TECHNICAL EVALUATION REPORT ON THE TENNESSEE VALLEY AUTHORITY'S  
PROPOSED METHOD TO CALCULATE ENVIRONMENTAL CONDITIONS  
INSIDE CONTAINMENT FOR QUALIFICATION OF SAFETY-RELATED ELECTRICAL  
EQUIPMENT DURING A MAIN-STEAM-LINE BREAK

J. N. Edwards  
Los Alamos National Laboratory

April 1987

Fig. 1. CVTR containment temperature profiles predicted with average CVTR heat transfer coefficients and bulk temperature with various reevaporization rates compared to maximum measured temperature profile (Ref. 3, Fig. 7).

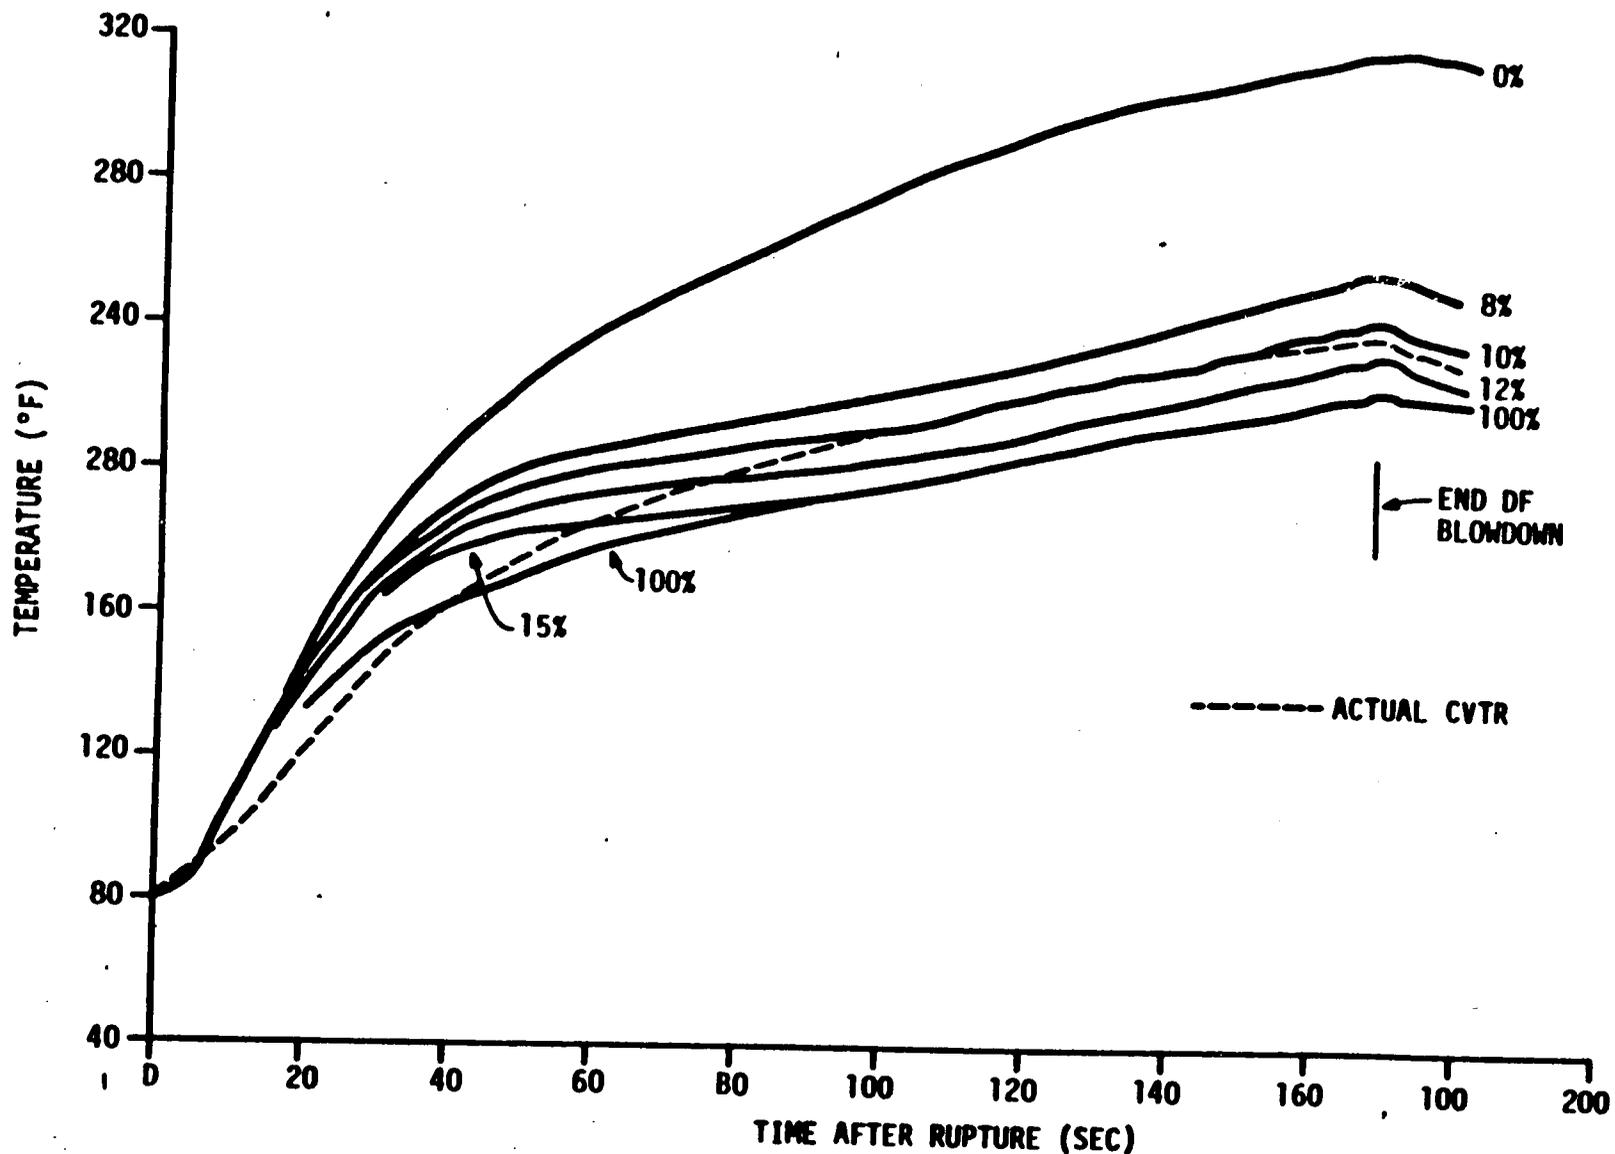
TVA first did a demonstration analysis of the Carolinas Virginia Tube Reactor<sup>2</sup> (CVTR) containment experiments using their MONSTER containment computer code.<sup>3</sup> For its analysis, TVA used the CVTR experimentally determined heat-transfer coefficients and parametrically varied the revaporization rate to achieve a good-fit analysis for the CVTR temperature data (Fig. 1). TVA chose a 10% revaporization rate and considered this analysis conservative because MONSTER over-predicted the maximum CVTR experimental temperature by

4°F. Considering the large spatial temperature variations observed in the CVTR tests (more than 100°F), Los Alamos disagrees with TVA's conclusion that theirs is a conservative analysis of CVTR.

These results demonstrate the conservative nature of the NUREG-0588 method. In Fig. 1, TVA's results of MONSTER calculations for CVTR using the average experimentally observed CVTR heat-transfer coefficients were presented. These heat-transfer coefficients are used with  $\Delta T$  based on the bulk atmosphere temperature. Results were plotted for various revaporization rates. Based on this figure, TVA proposes that the calculation using 10% revaporization is a conservative evaluation for CVTR. This is an important point in their analysis; however, in looking at Fig. 1, Los Alamos cannot agree. First, based only on the figure, the 10% curve lies right on top of the experimental data for a significant portion of the time and ends up 4°F higher at the peak. This is not a conservative estimate in our opinion, particularly when you consider that a temperature stratification of more than 100°F was observed

Fig. 2. NRC's comparison of various revaporization rates used in modeling the CVTR test data (Ref. 8) (Ref. 5, Fig. 3 and Ref. 3, Fig. 1).

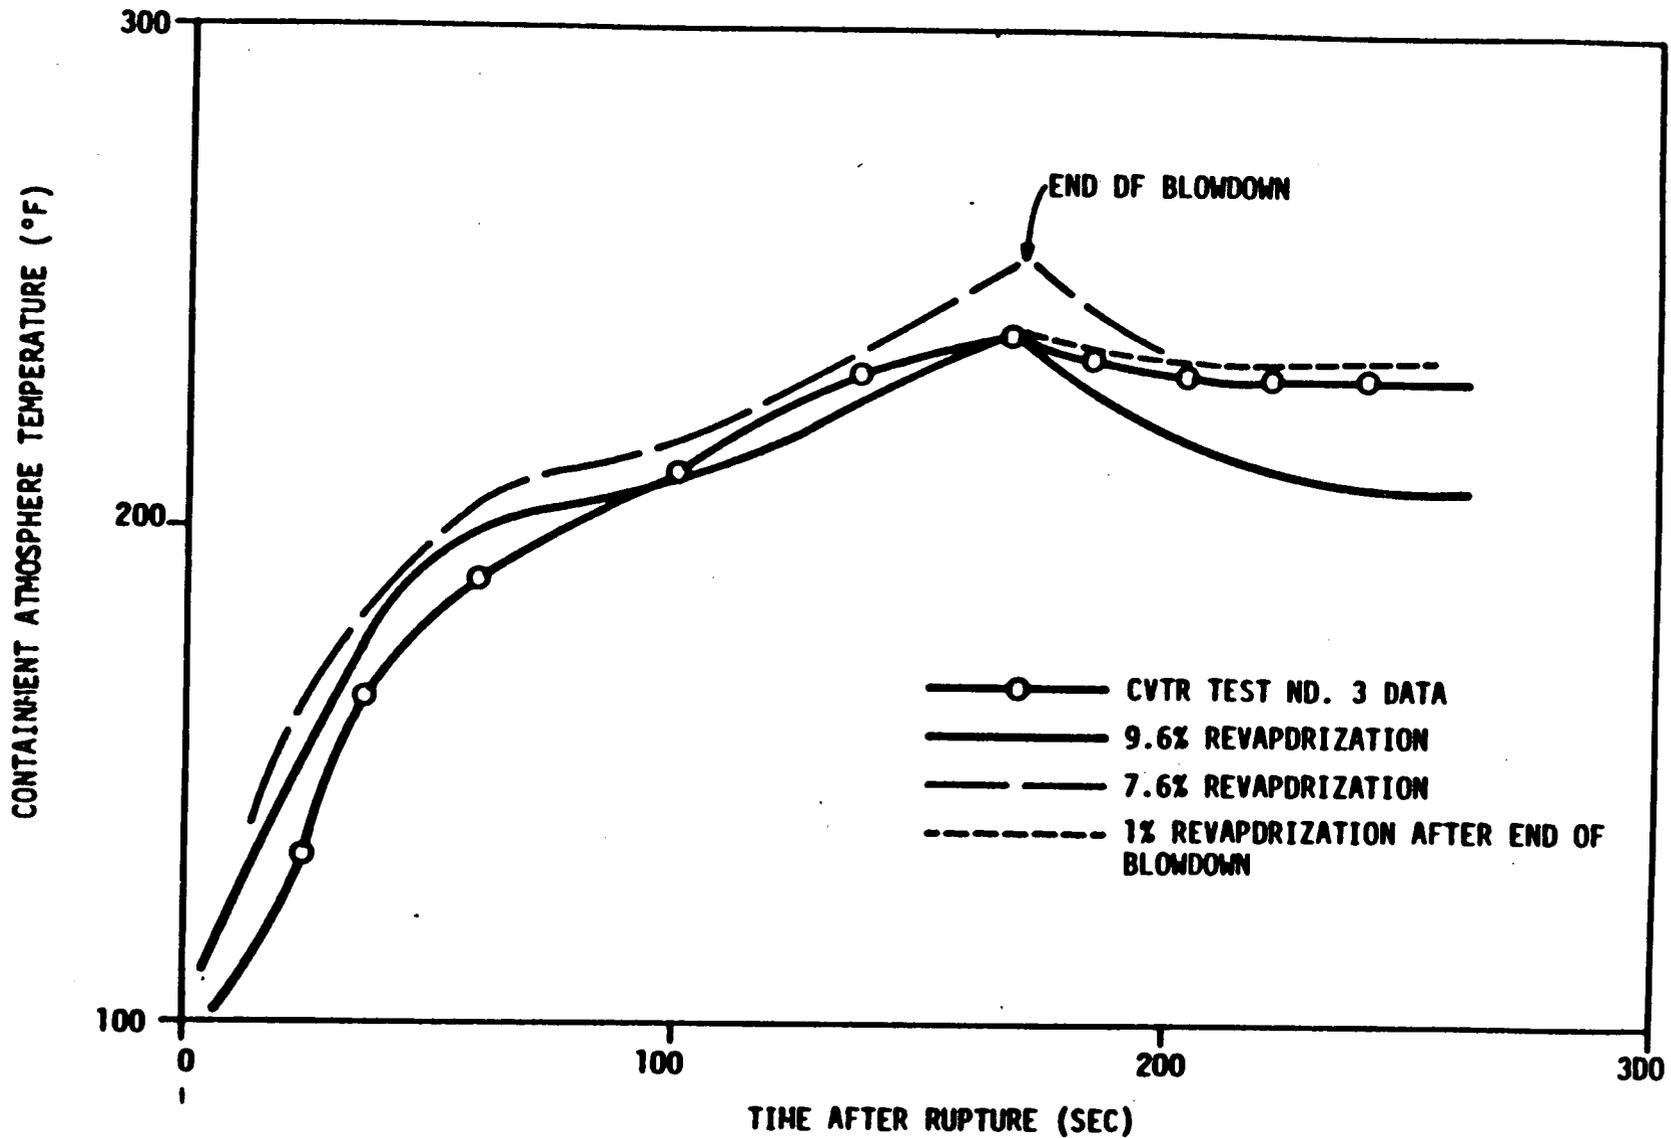
condensate remains in the liquid state in the post-blowdown phase. In Fig. 2 (Tedesco's Fig. 3), the CVTR test results are compared with temperatures predicted using revaporization rates of 9.6% and 7.6%. They note that a revaporization rate of 9.6% gives a best fit to the CVTR data and that 7.6% bounds the CVTR data. A revaporization rate of 7.6% is used for the remainder of the analyses presented in Ref. 5.

We have reviewed this issue and conclude that the analysis reported in Ref. 5 (Fig. 2) was done as intended. We believe it was NRC's intention to do a best-estimate calculation for CVTR and determine the best value to use for revaporization rate. For the CVTR data, the actual CVTR heat-transfer coefficients are the best estimate. We acknowledge that it was unfortunate that the heat-transfer coefficient that was used was not reported.

We do note that, in looking at all of the other figures in Ref. 5, the heat-transfer coefficient being used (where appropriate) is stated, and in all cases it is the Tagami and/or Uchida correlation. It is easy to see why TVA would have assumed that Tagami and Uchida had been used for Fig. 2.

Fig. 3. CVTR containment temperature profiles predicted with Uchida correlation and saturation temperature compared to maximum measured temperature profile (Ref. 3, Fig. 2).

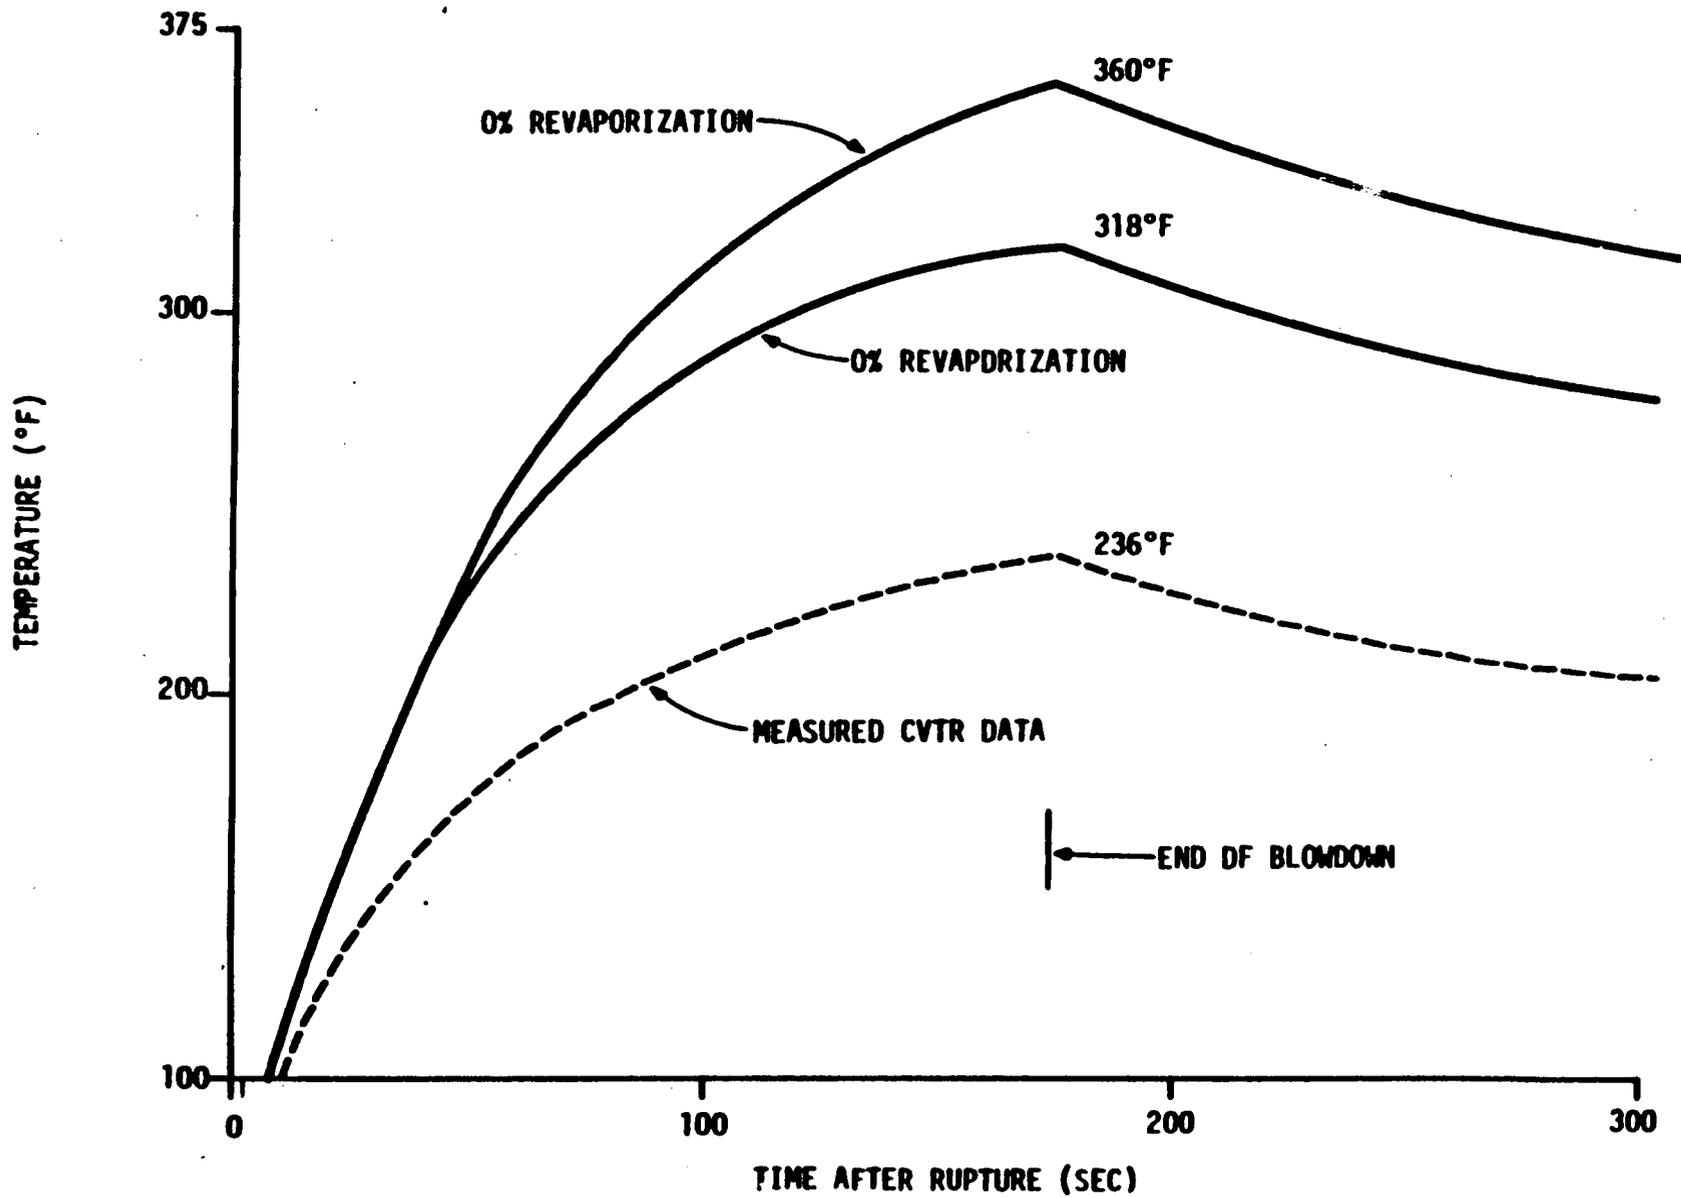
In Fig. 3 (TVA's Fig. 2 from Ref. 3), TVA presents the results of a MONSTER computer code analysis of the CVTR experiments using the NRC NUREG-0588 required methods showing the hottest CVTR experimental temperatures and the temperatures calculated using the Uchida correlation with  $\Delta T$  based on the saturation temperature and calculated for 0% and 8% revaporization. The peak temperatures are as follows.

CVTR experimental value: 236°F  
MONSTER with 8% revaporization: 318°F  
MONSTER with 0% revaporization: 360°F

In Sec. II.C.1 of their report,<sup>3</sup> TVA compares their method with the NUREG-0588 recommended analysis for the CVTR experiment. Figure 3 shows that TVA calculated a peak temperature for CVTR test 3 of 360°F using 0% revaporization and 318°F using 8% revaporization, as compared with the CVTR experimental value of 236°F. For these calculations TVA used the NUREG-0588 Appendix B method with the Uchida correlation and the temperature difference based on the saturation temperature. TVA compared their results with Fig. 3 of Ref. 5 (our Fig. 2) in which NRC calculated a peak temperature of 250°F using a 7.6% revaporization rate. TVA could not explain the difference between their calculated peak temperature of 318°F and NRC's calculated peak temperature of 250°F for what TVA believed to be identical calculations. Unfortunately, the NRC calculation (Fig. 2) does not state explicitly what heat-transfer coefficients were used. TVA requested that NRC provide additional information, and Los Alamos sent three code input decks to TVA. Upon examining these decks, TVA found that the heat-transfer coefficients used were the actual CVTR values and not the Uchida model that TVA used and that is required by NUREG-0588. TVA raised the question as to whether this was intended or was in error.

Fig. 4. CVTR average heat transfer coefficients measured and scaled for Bellefonte MSLB (Ref. 3, Fig. 10).

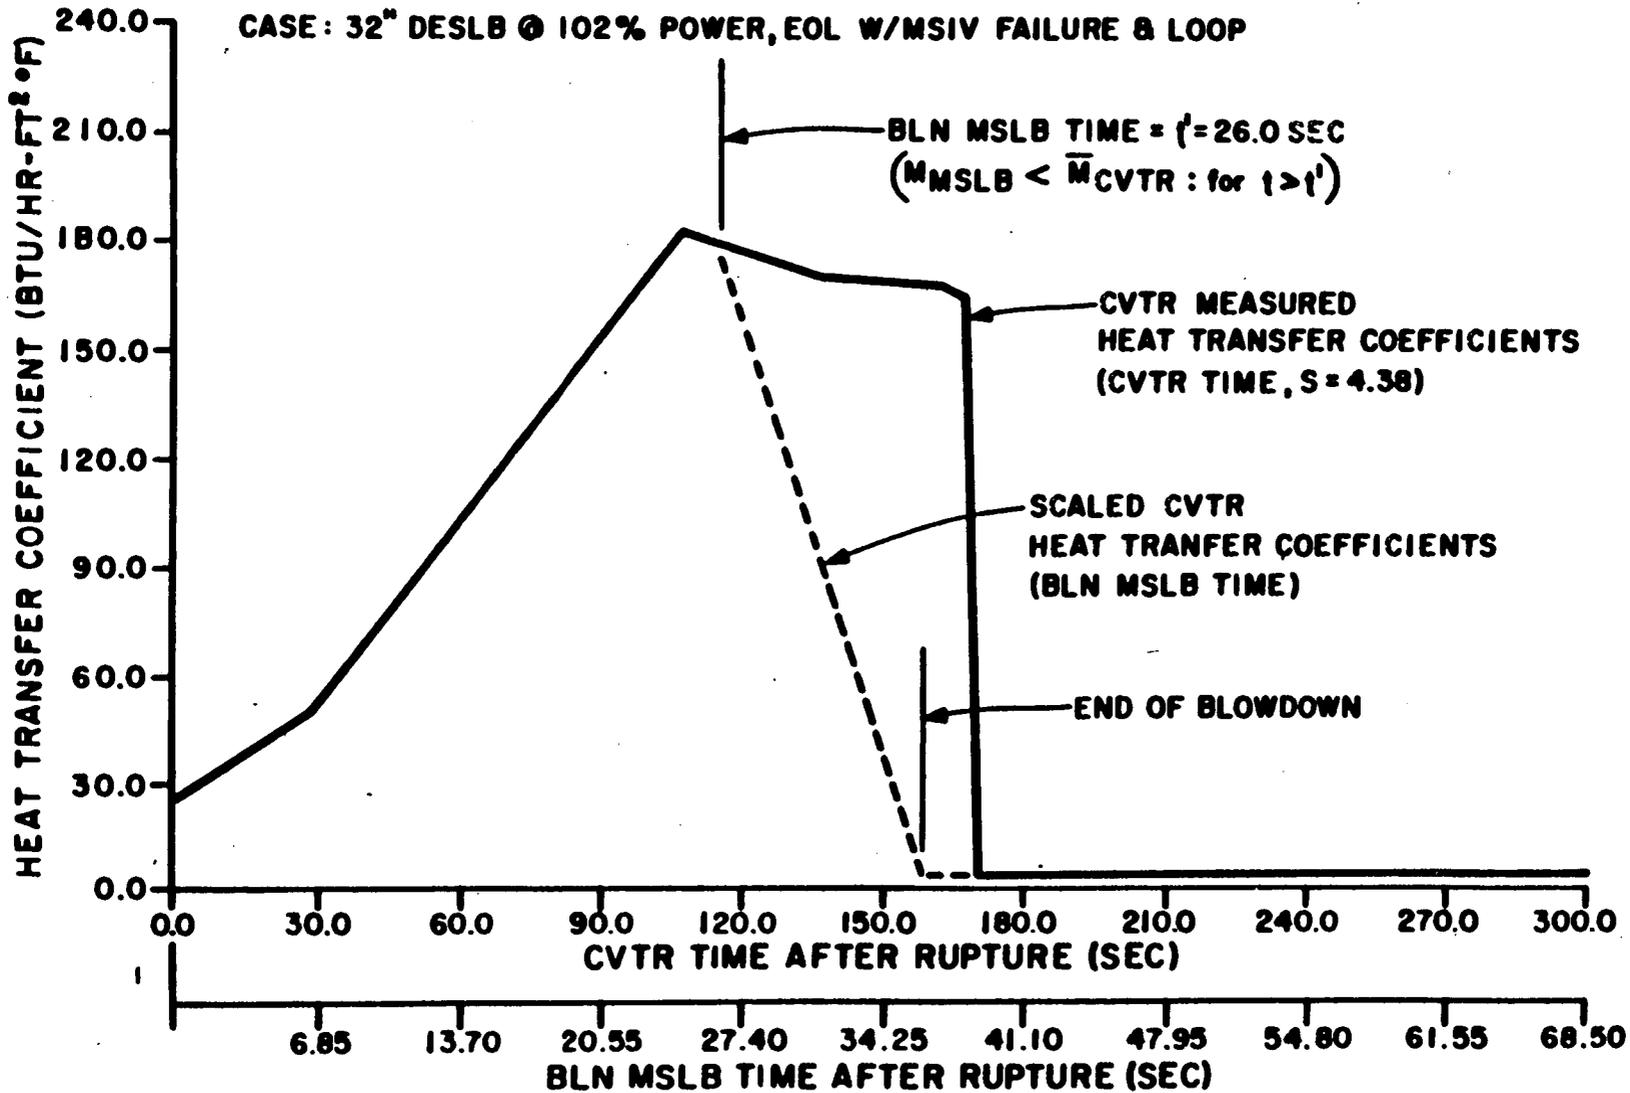
scale by a factor of 4.38 to account for the relative magnitudes of BLN's integrated blowdown rate per unit volume compared with the integrated blowdown rate per unit volume for CVTR. Figure 4 shows the results of this scaling operation. This means that the time of the peak heat-transfer coefficient in BLN is  $1/4.38$  of the time of the peak for CVTR. The peak occurs about 110 s for CVTR and 26 s for BLN. Calculatively, this earlier peak heat-transfer coefficient will reduce the peak temperatures calculated for BLN.

The method of scaling that TVA has developed is not supported by any data independent from CVTR nor are the effects on containment temperature calculation evaluated by sensitivity studies.
